Certificate of Appropriateness

3402 W. ST PAUL AV. **Weinstock Historic House**

PTS ID 79299 COA, dismantle and rebuild front brick porch

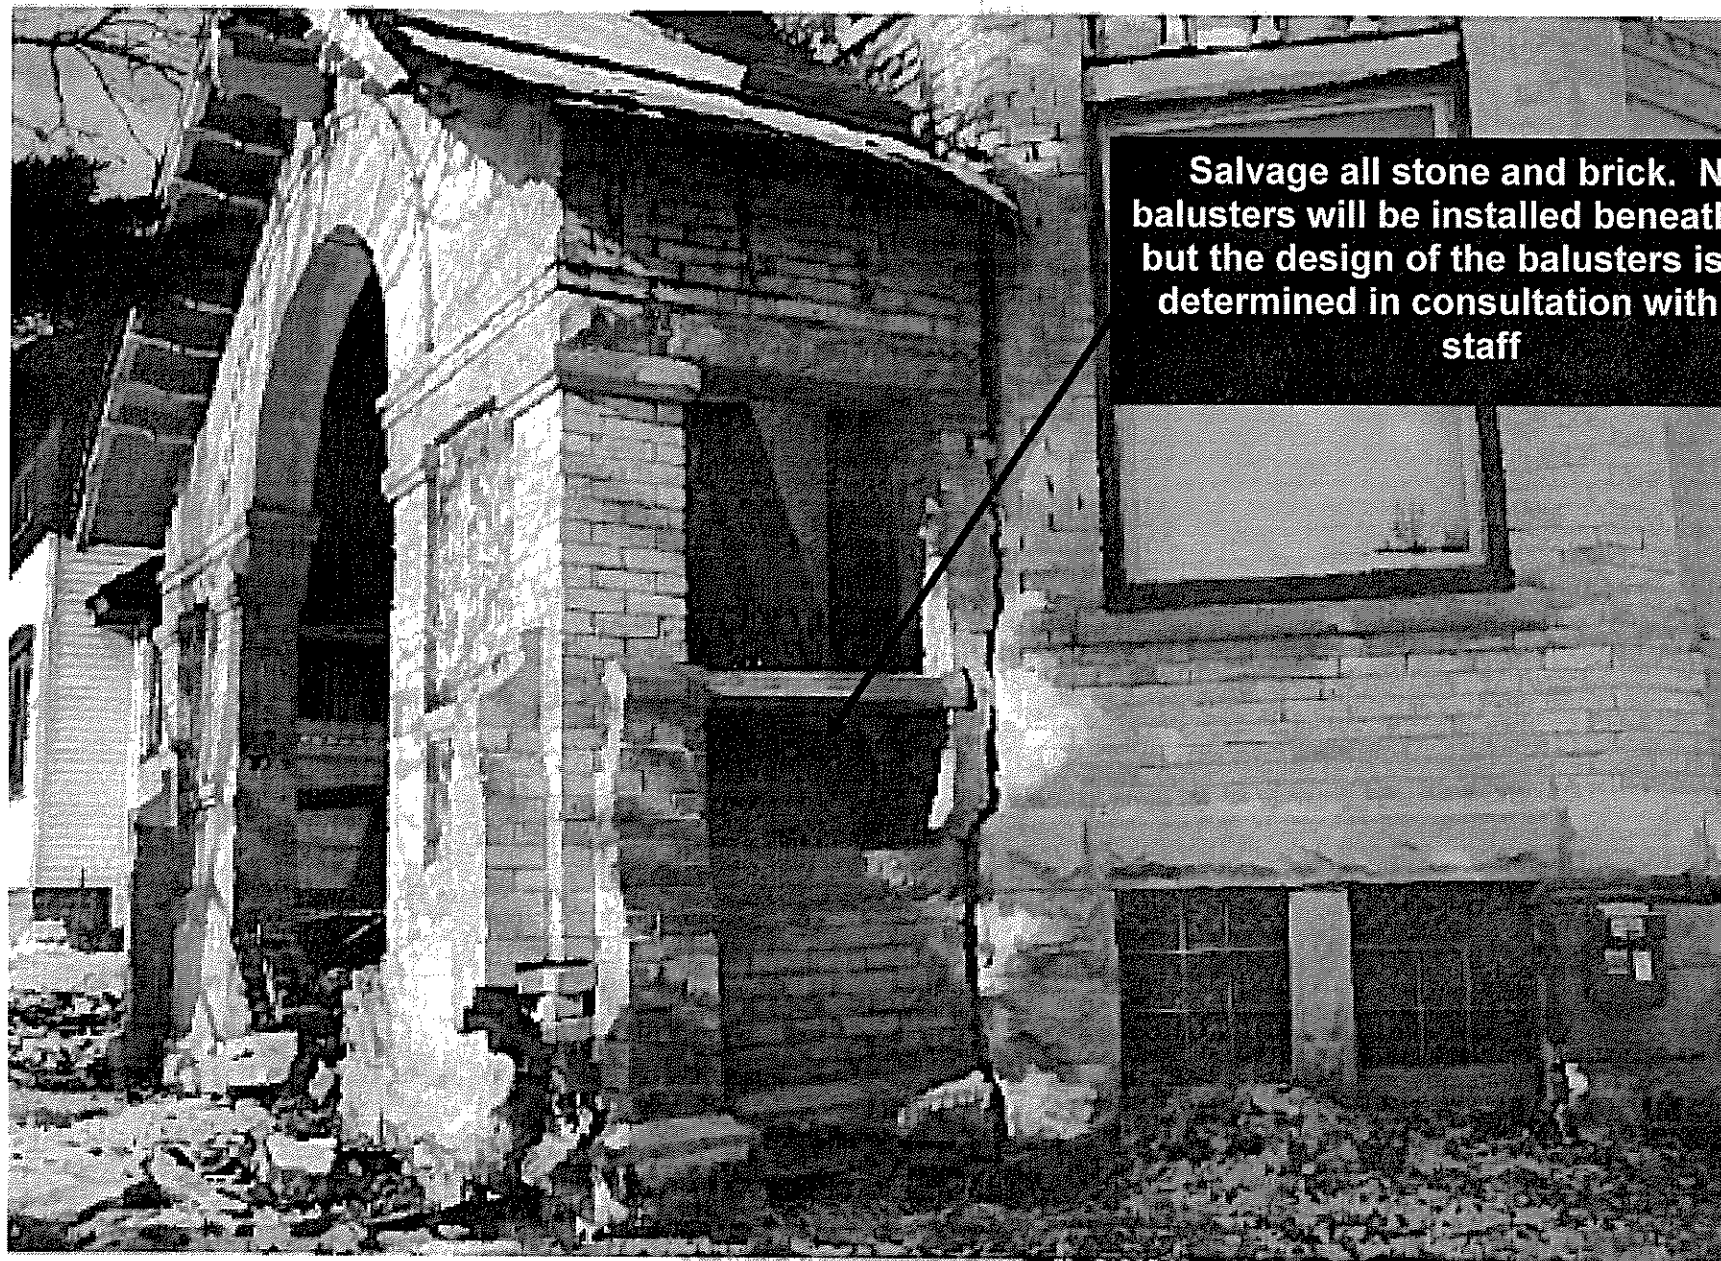
Brick front porch to be carefully dismantled and rebuilt on new foundation. Measured drawings of the porch must be made and approved by HPC staff prior to general construction.

Salvage all stone and brick. New balusters will be installed beneath rails, but the design of the balusters is to be determined in consultation with HPC staff

Side view of porch looking northwest.

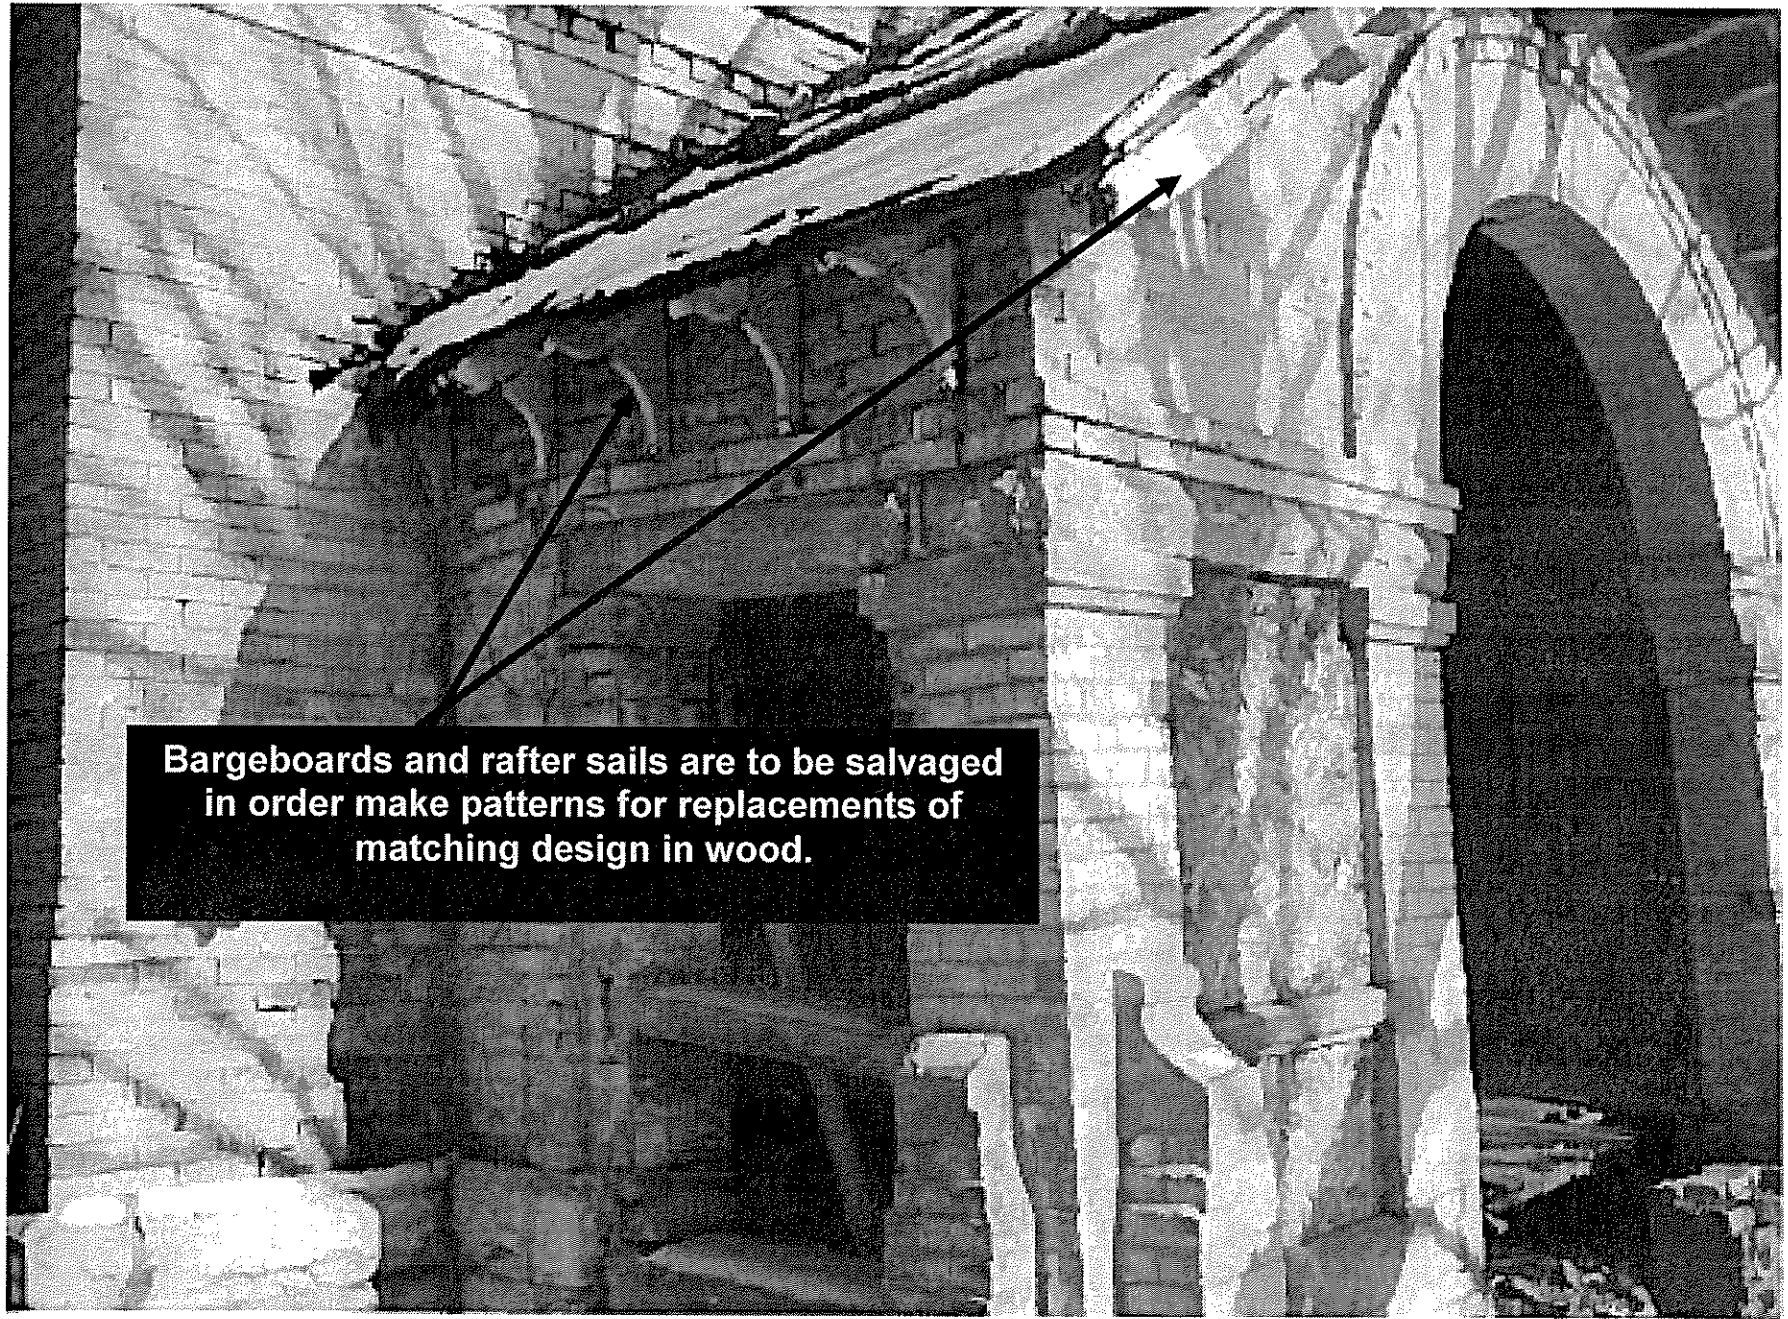
Bargeboards and rafter sails are to be salvaged in order make patterns for replacements of matching design in wood.
